## DEVIATION REVIEW AND DECISION FORM

Subdivision or Project Name: Falcon Marketplace

Revision Issued: SP-17-001 - Deviation #1 - Eastonville Road Full Access (Rev. 9-21-18)

Figure 4

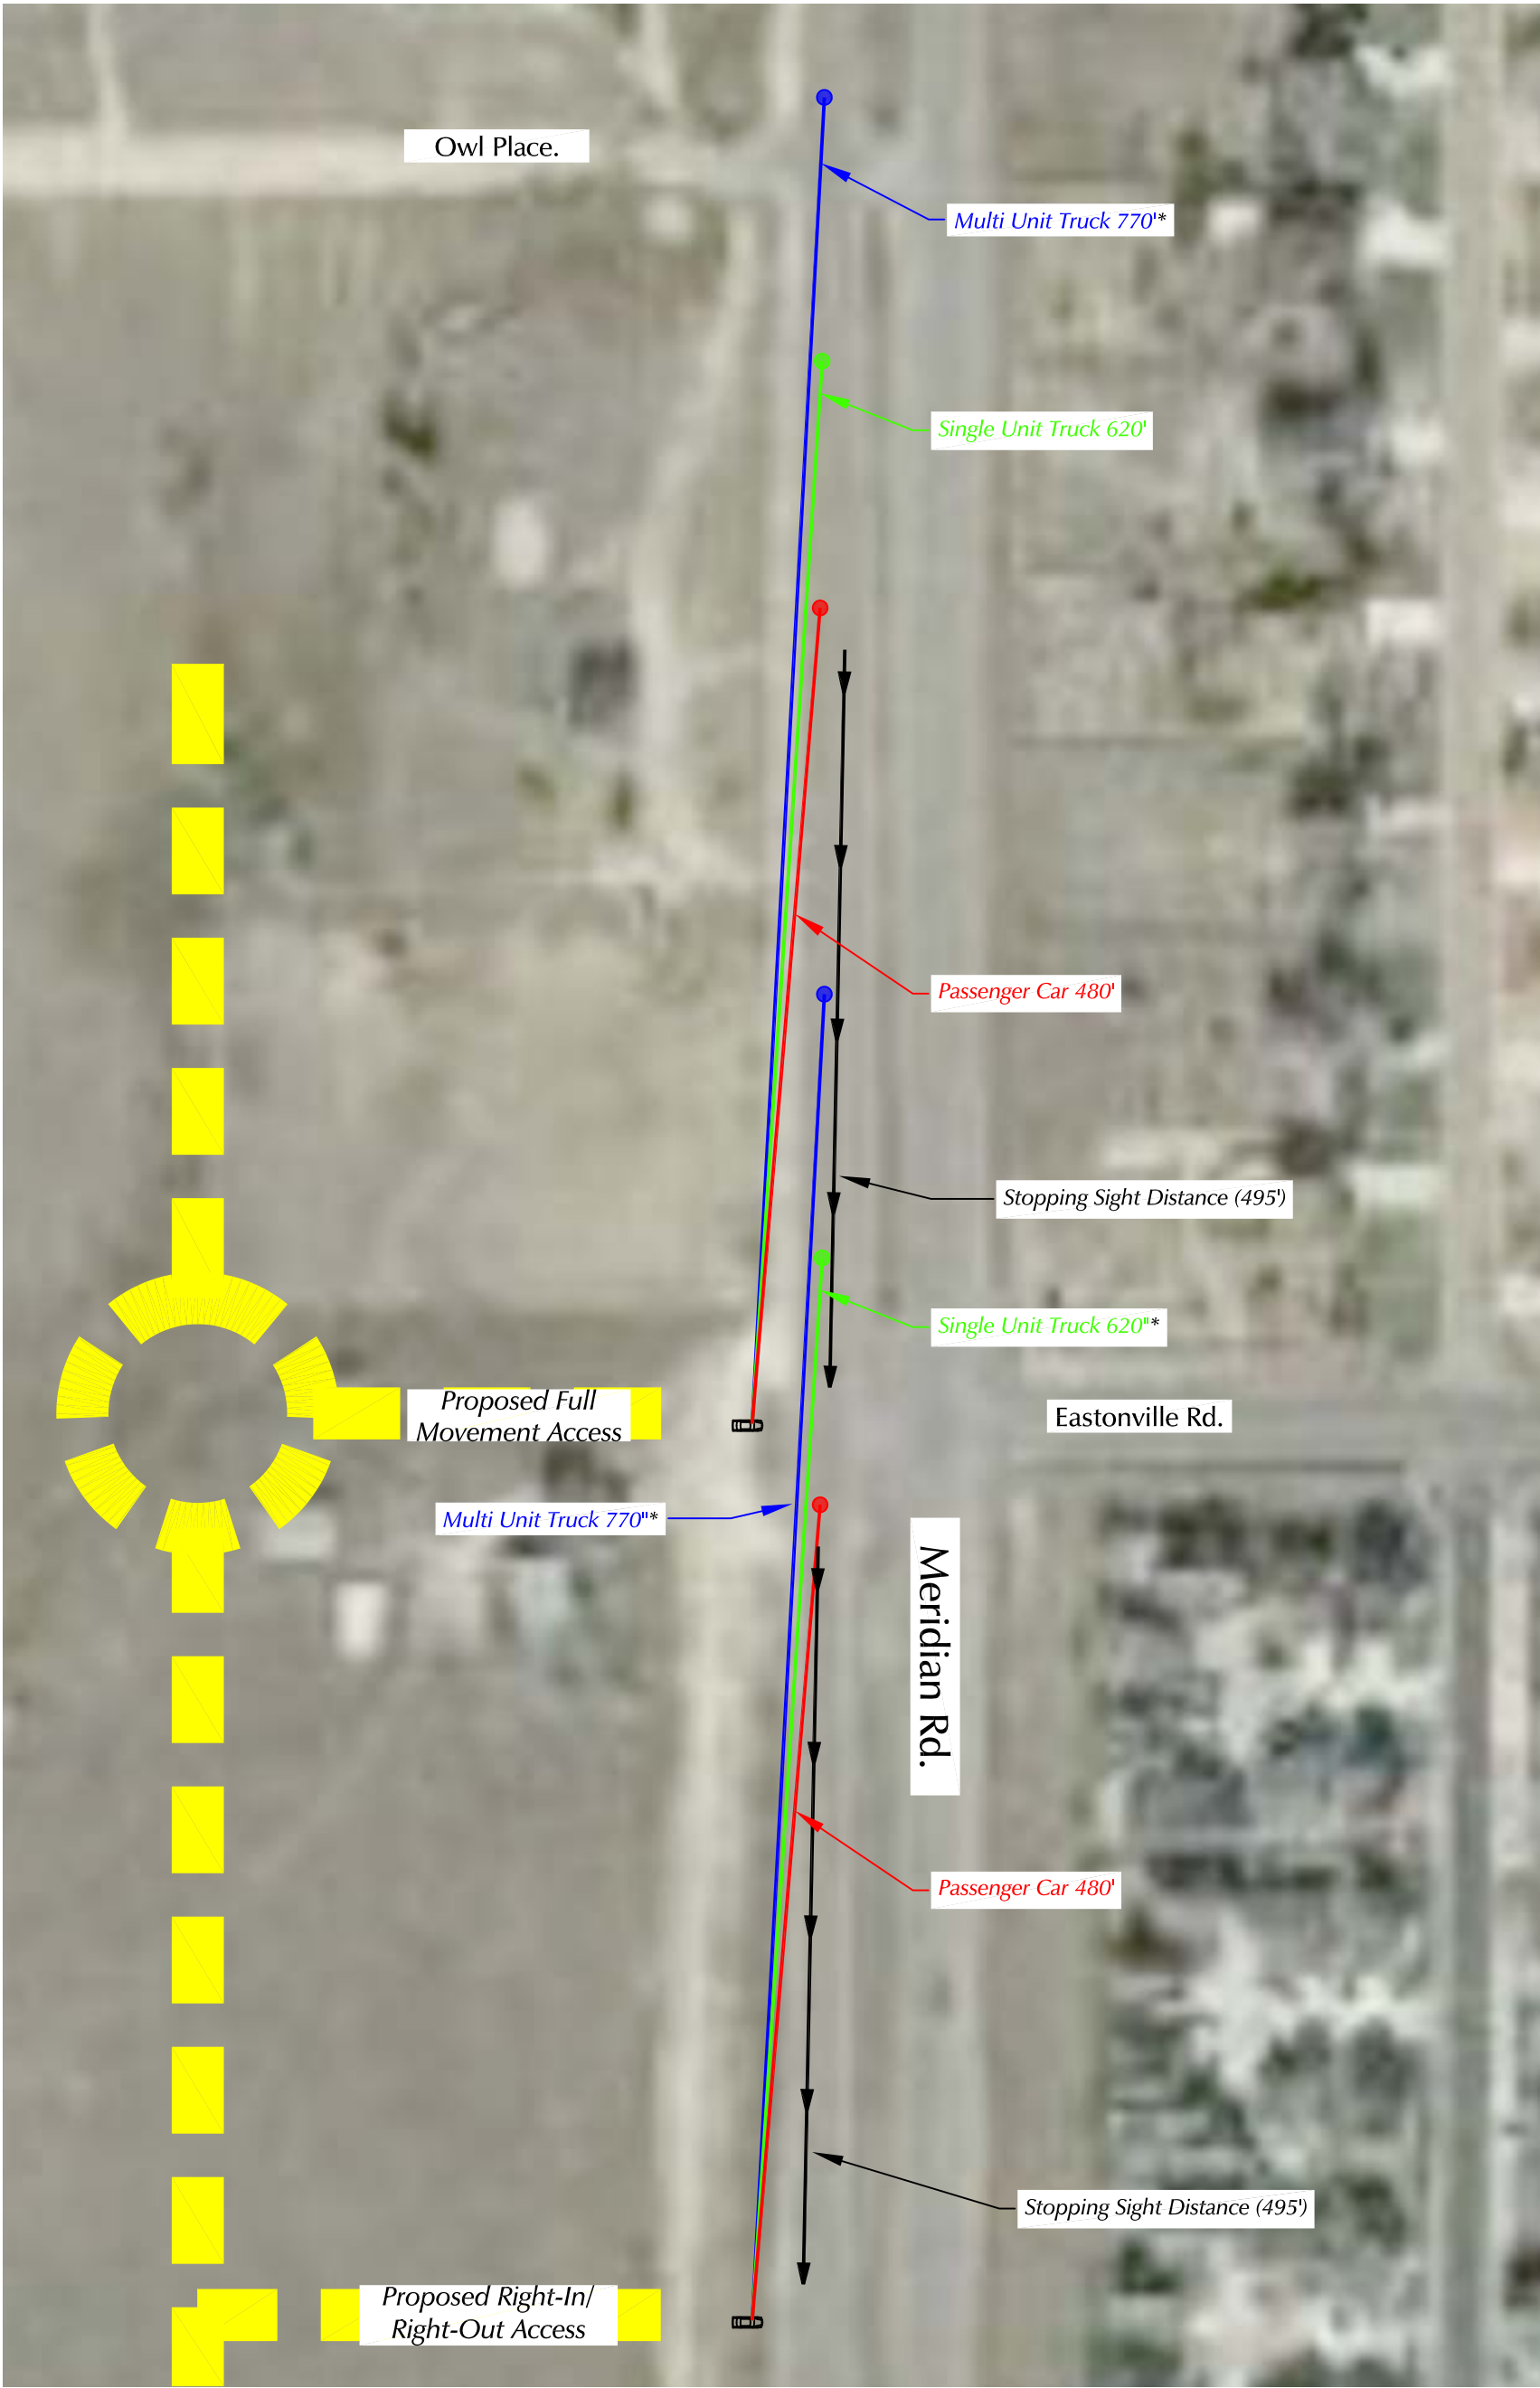
Please refer to the accompanying traffic impact study (TIS) for details and the traffic operations analysis. The TIS also includes exhibits requested by staff showing intersection/access spacing, acceleration and deceleration lengths and sight distance. The applicable exhibits are attached to this deviation.
